Strathfield Local Planning Panel Meeting

Thursday, 7 March 2019

TO: Strathfield Local Planning Panel Meeting - 7 March 2019
REPORT: SLPP – Report No. 1
SUBJECT: DA2018/176 - 12-14 ELWIN STREET, STRATHFIELD
LOT 1 DP 324569
DA NO. DA2018/176

Proposal: Construction of a two (2) storey dwelling with a basement level, swimming pool and front boundary fence.

Figure 19: Height plane diagrams showing the extent of the non-compliance with the 9.5m maximum height standard (bottom, shown in blue), and non-compliance with a 10.45m height plane (top, shown in yellow)

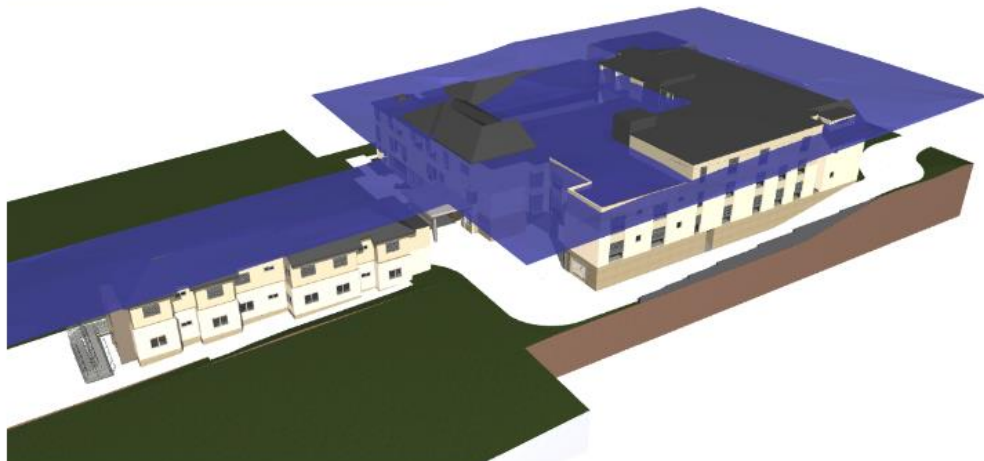
A maximum building height of 9.5m is prescribed for the site. The roofing above the proposed above the additional floor level exceeds this height limit by up to ~1.6m (16.84%). There are existing parts of the building which exceed the height development standards, but this is to the central portion of the rear of the Albert Road building. The extent of non-compliance is shown in **Figure 19**.

Figure 21: The subject site highlighted in blue, consolidated plan identified in Appendix 1 of Part C outlined in red and the isolated site identified as No. 60 Beresford Road.

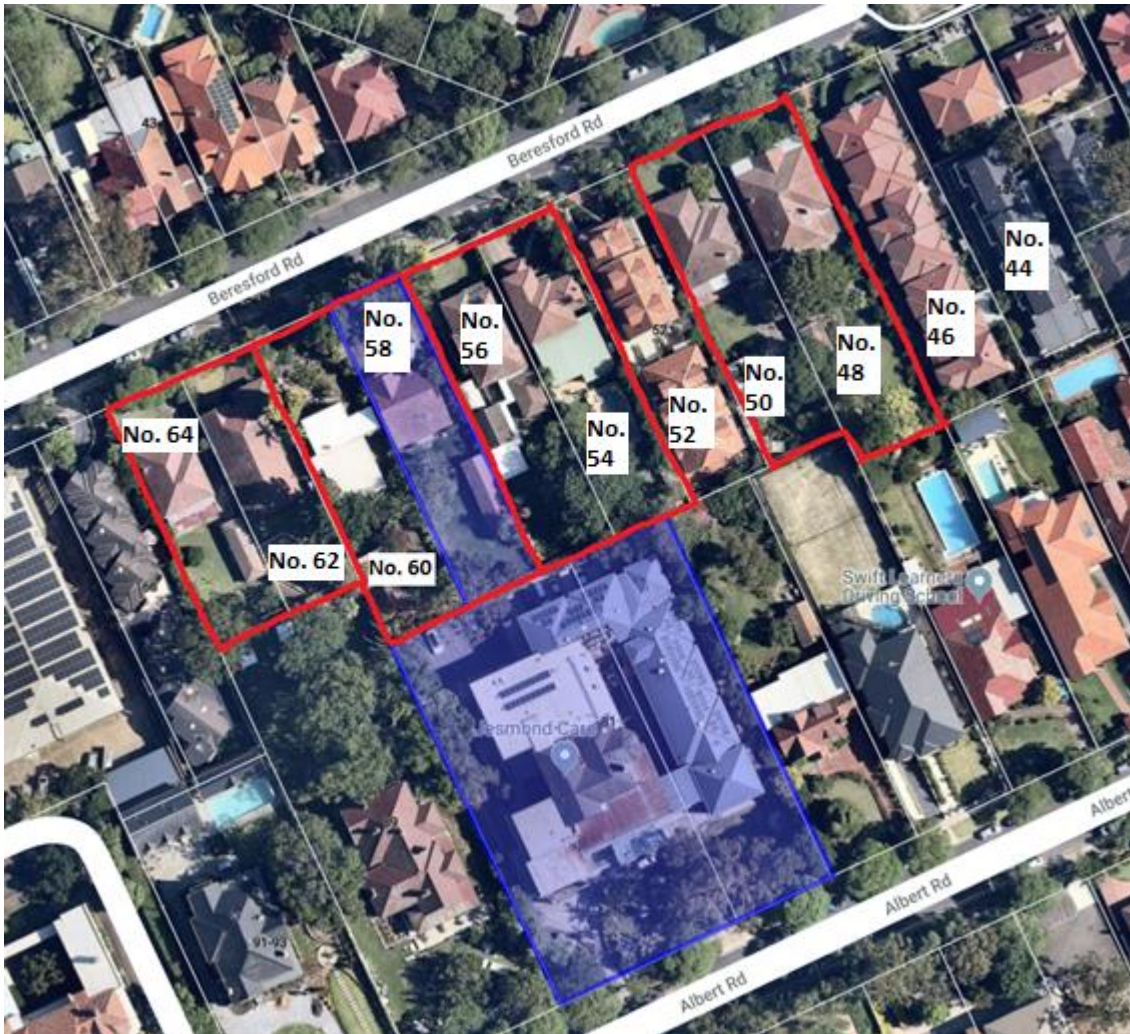
Appendix 1 of Part C sets out the desired consolidation pattern for a number of medium density residential areas across the local government area. Map 4 specially relates to the site, and stipulates that No. 58 Beresford Road should be amalgamated with No. 60 for the purposes of townhouses and villas (**Figure 20**). Whilst the proposal is not for townhouses and villas, without amalgamating the site with No. 60, this will result in the potential isolation of No. 60 and thereby comprising its redevelopment potential in the R3- Medium Density Residential zone. As shown in **Figure 20** and **Figure 21**, the south-western side of Beresford Road has already partly been redeveloped for townhouses and villas and the consolidation pattern in Map 4 has been followed. The redevelopment of the other properties, namely No. 46 and No. 52 Beresford Road was undertaken before the implementation of SDCP 2005.
